Addendum 1 August 9, 2024

Request for Proposals SJPC-24-E7 Building B Sanitary Pump Station Repairs Balzano Marine Terminal

1. Electrical room. Main panel on the right. Subpanel on the left.

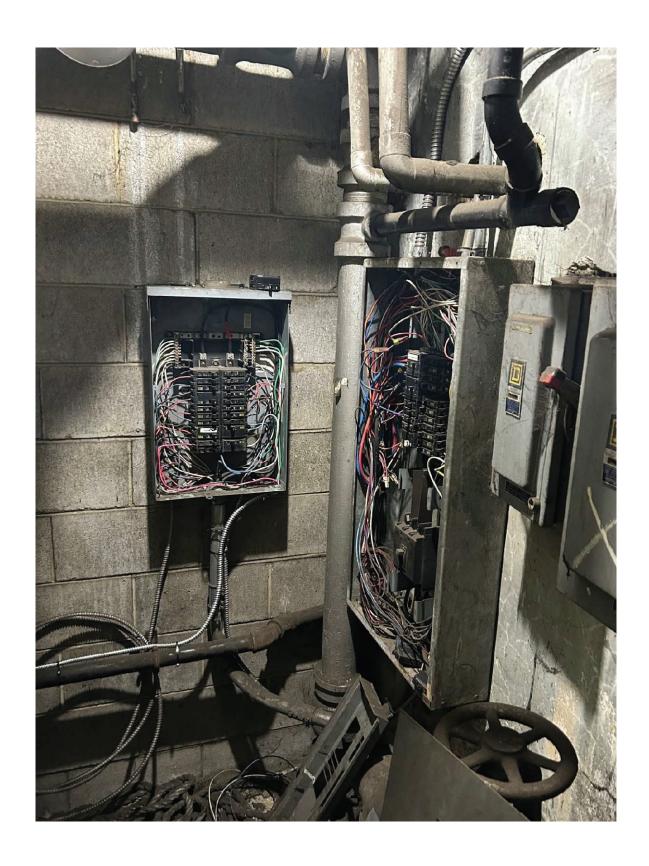
Answer 3. See photos 1 and 2 below. The main panel to the building in the adjacent electrical room is 208 volt, 3 phase. The old motor controllers are fed from a smaller subpanel shown in the photo, at 208 volt, single phase.

The contractor shall provide and install a new main panel, 208 volt, 3 phase, 150 amps, with 36 circuit positions. The new motor controllers shall be fed from the new panel.

3. Existing Upstream Disconnect Panel is located here.

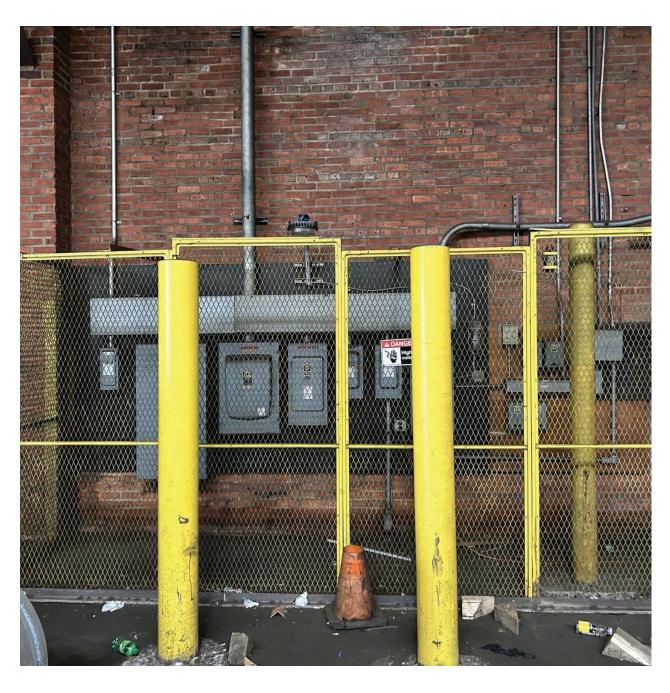
In addition, the contractor shall install new wiring back to the upstream disconnect panel which is located on the inside east wall of the building approximately 120 feet away. See photo Number 3. Include the new panel and wiring under revised Bid Form Item 5A, Electrical work to replace main breaker panel and feeder.
